# ADDENDUM

**PROJECT: Clovis Landmark Square  
Senior Activity Center and Transit Center**

**ADDENDUM#: 02**

**PUBLISHED DATE: October 30, 2020**

SECTION K  
S404

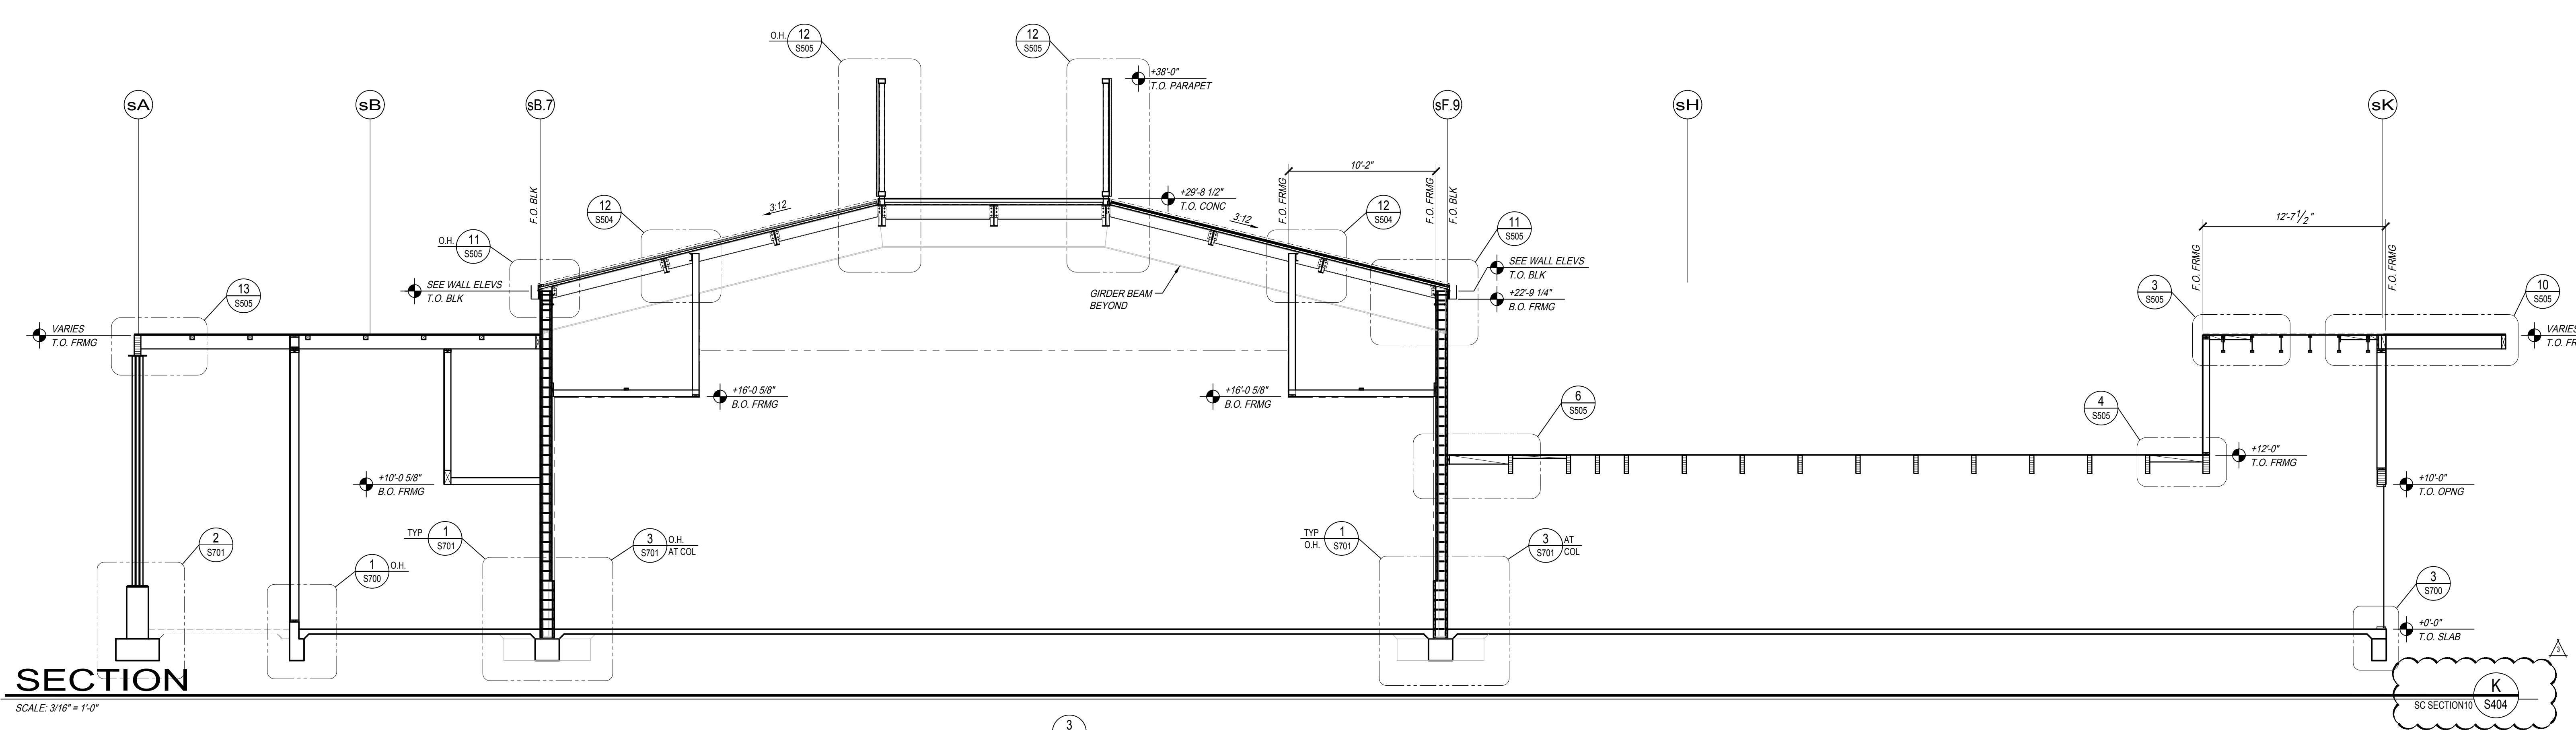
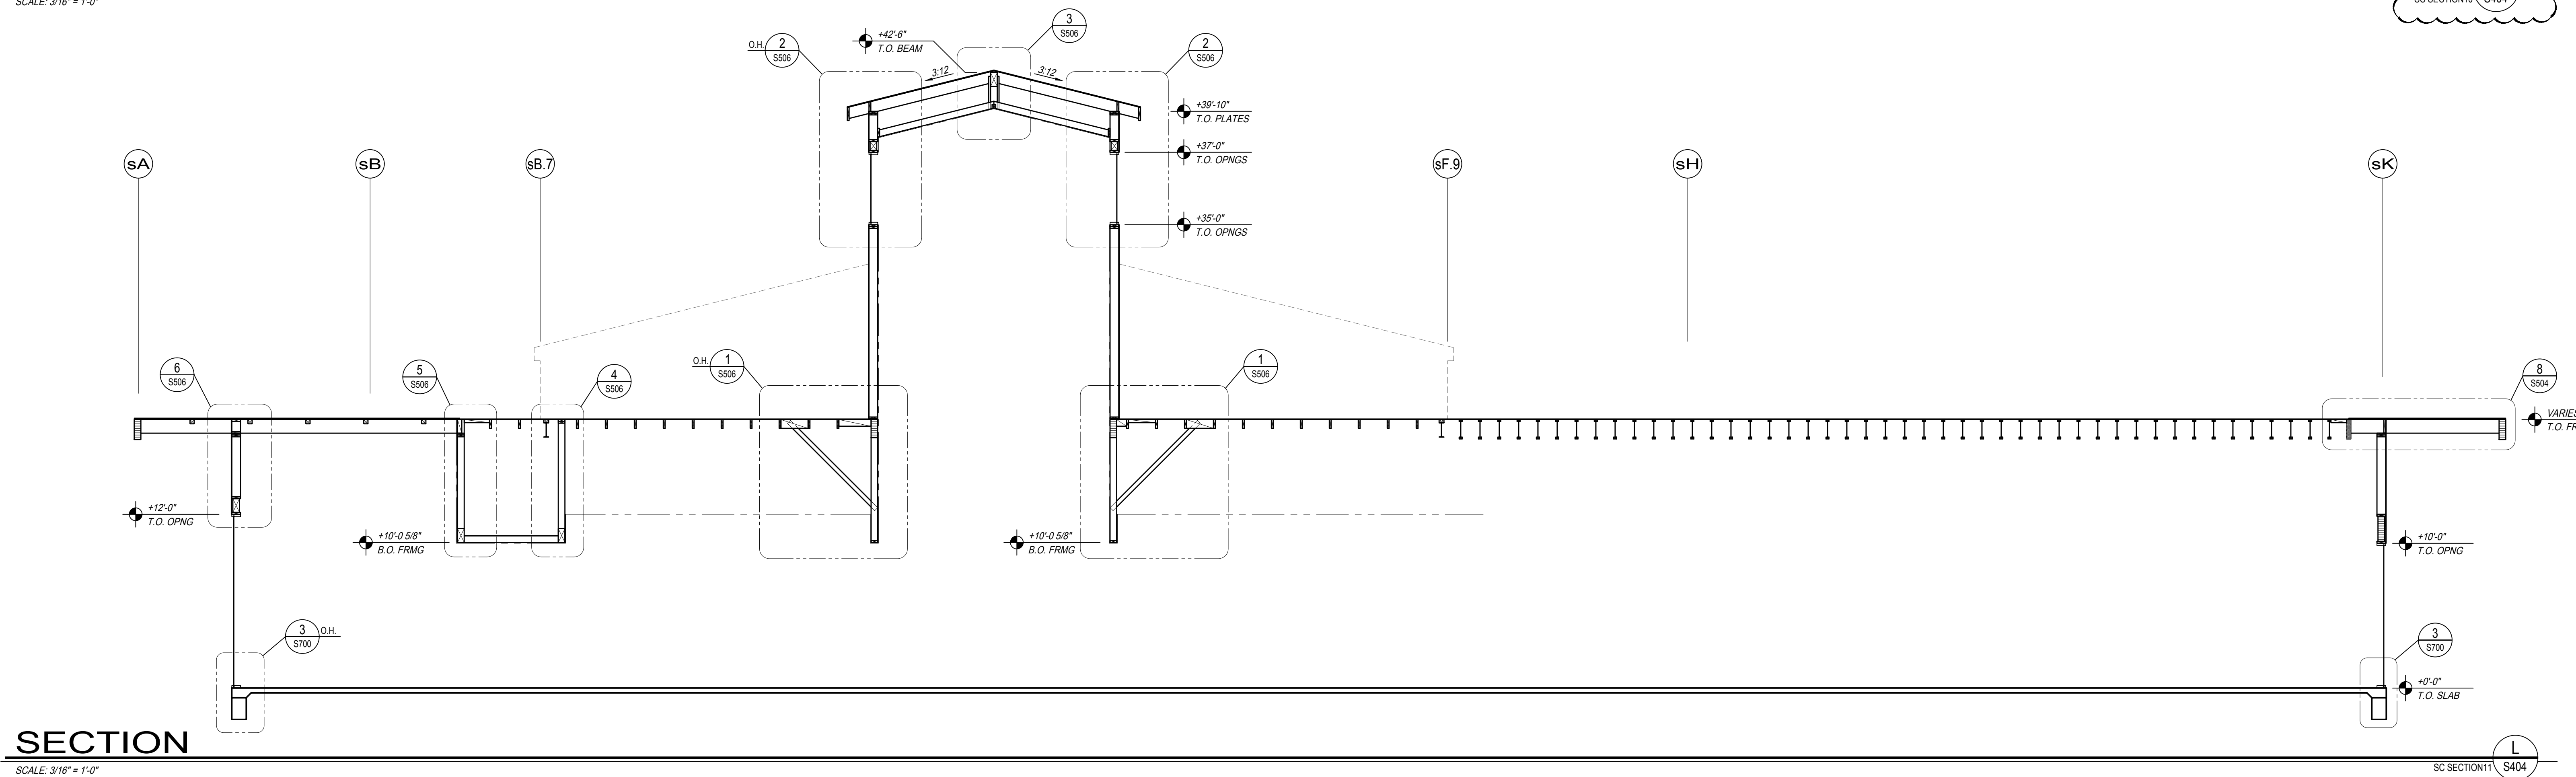
- a. Omit sheet **S404, Senior Activity Center-Sections** and replace with **AD2-S404, Senior Activity Center-Sections** attached. The following changes have been made:
  - i. Refer to section K/S404 - Eave conditions have been revised on each side.

**DETAIL 3**  
 SCALE: 1" = 1'-0"  
 BM02 S600

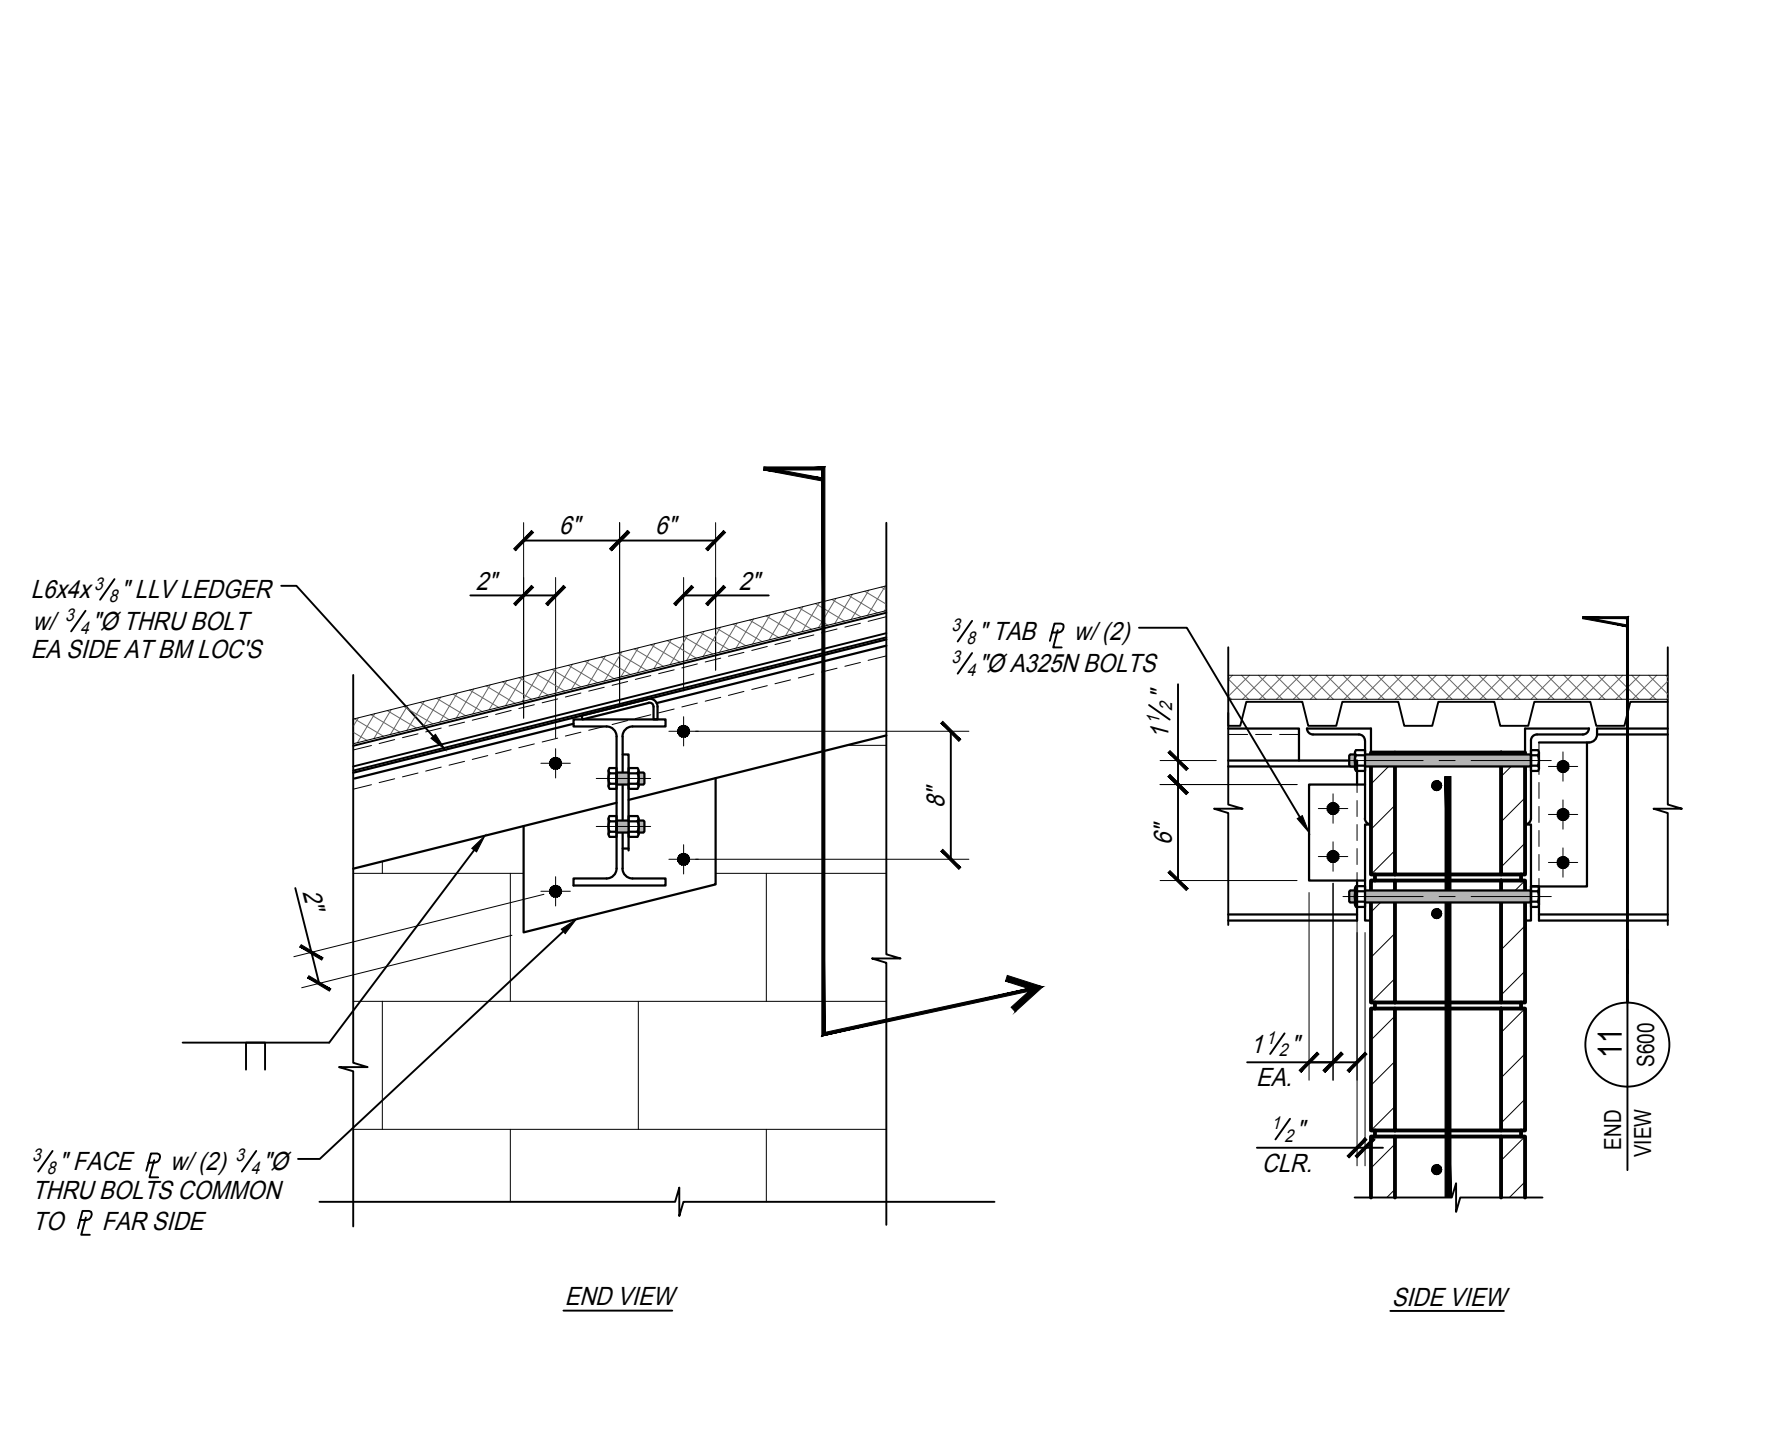
- a. Omit sheet **AD1-S600, Beam Details** and replace with **AD2-S600, Beam Details** attached. The following changes have been made:
  - i. Refer to detail 3/S600 – Revised beam connection to block wall. Beam pocket has been eliminated.
  - ii. Refer to detail 8/S600 – Revised beam connection to block wall. Beam pocket has been eliminated.
  - iii. Refer to detail 9/S600 – Revised beam connection to fascia.
  - iv. Refer to detail 10/S600 – Revised beam connection to fascia.
  - v. Refer to detail 11/S600 – Revised fascia beam.
